**STAFF ANALYSIS  
OF THE  
WHITE ROSE DEVELOPMENT PLAN  
AMENDMENT APPLICATION**

**SOUTH WHITE ROSE EXTENSION TIE-BACK**

**APRIL 26, 2013**

Figure 4.12: East and West fault blocks in the southern Terrace gas cap area.

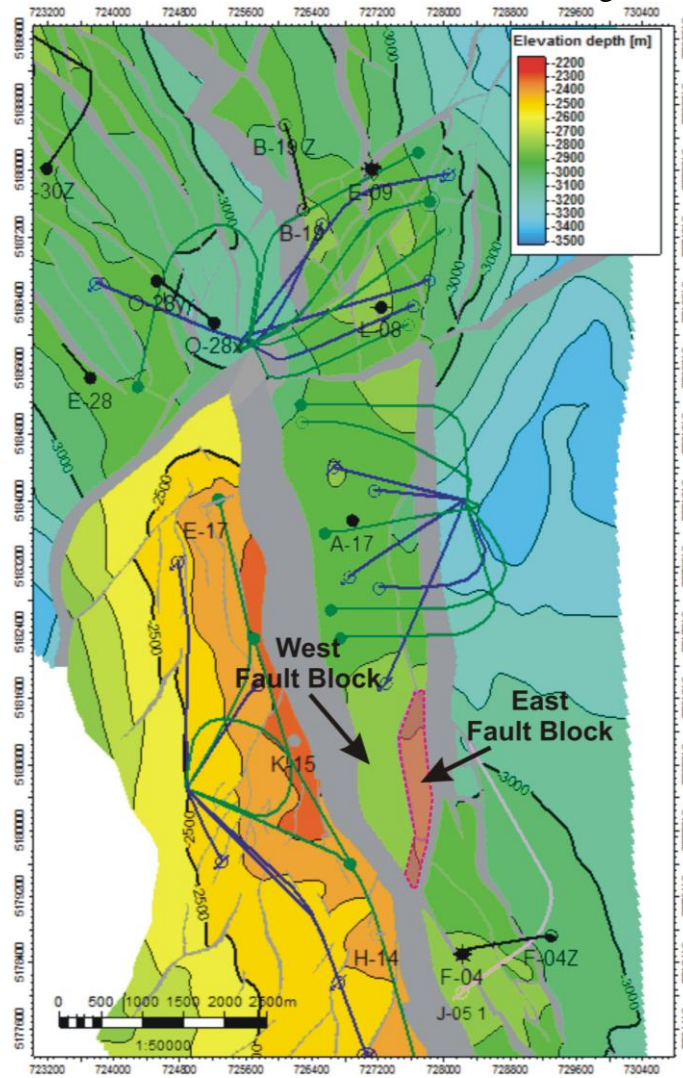
Board staff considers the Proponent's plans for reservoir management in the South Avalon Pool to be reasonable. However, if the fault separating the East and West fault blocks is sealing, the gas initially injected in the heel section of the injector will not aid in gas flooding the production wells in the southern Terrace region. Consequently, this injection would be considered gas storage, not gas flooding. The sealing nature of this fault will not be known until the Proponent is able acquire adequate injection and pressure data. As a result, **the Proponent will be required to submit a report acceptable to the Board assessing the sealing nature of the fault separating the East and West blocks one year after the commencement of gas injection in the southern Terrace.** If injection and pressure data from the gas injector indicates that the fault is sealing, the Proponent will have to apply for a subsurface gas storage license in the East fault block.

1. The Proponent must submit a report acceptable to the Board assessing the sealing nature of the fault separating the East and West Fault blocks one year after commencement of gas injection into the southern Terrace.
2. Should the period of gas injection prior to oil production in the SWRX Pool extend beyond 18 months, the Proponent must submit a report acceptable to the Board detailing the activities to date and future plans for gas injection in the SWRX Pool.

Figure 4.25: SWRX production rate and cumulative – base case vs. no gas injection.

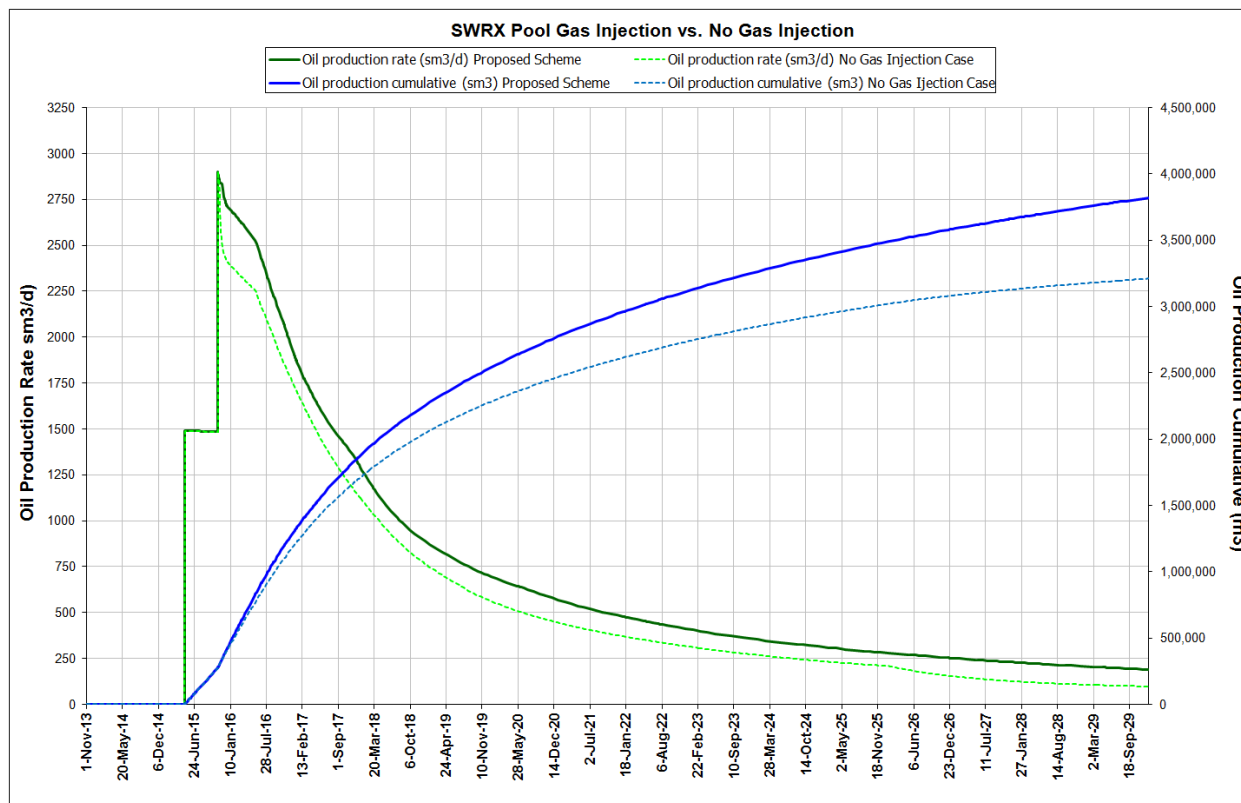
Based on alternate cases run on the SWRX reservoir simulation model, the proposed exploitation scheme with two oil producers, one gas injector and one water injector has the highest ultimate recovery of all the cases examined. While the difference in ultimate recovery in all cases is not significant, the proposed scheme has the added benefit of alleviating gas storage capacity concerns within the White Rose asset.
